**Subject: RFQ #2183-A: Fire Station 2 Fuel Tank Installation  
Addendum #1**

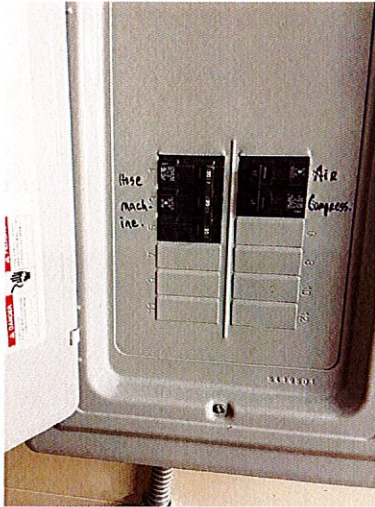
5. Please provide pictures of existing electrical panel to see if it will suffice for the new proposed fueling equipment.
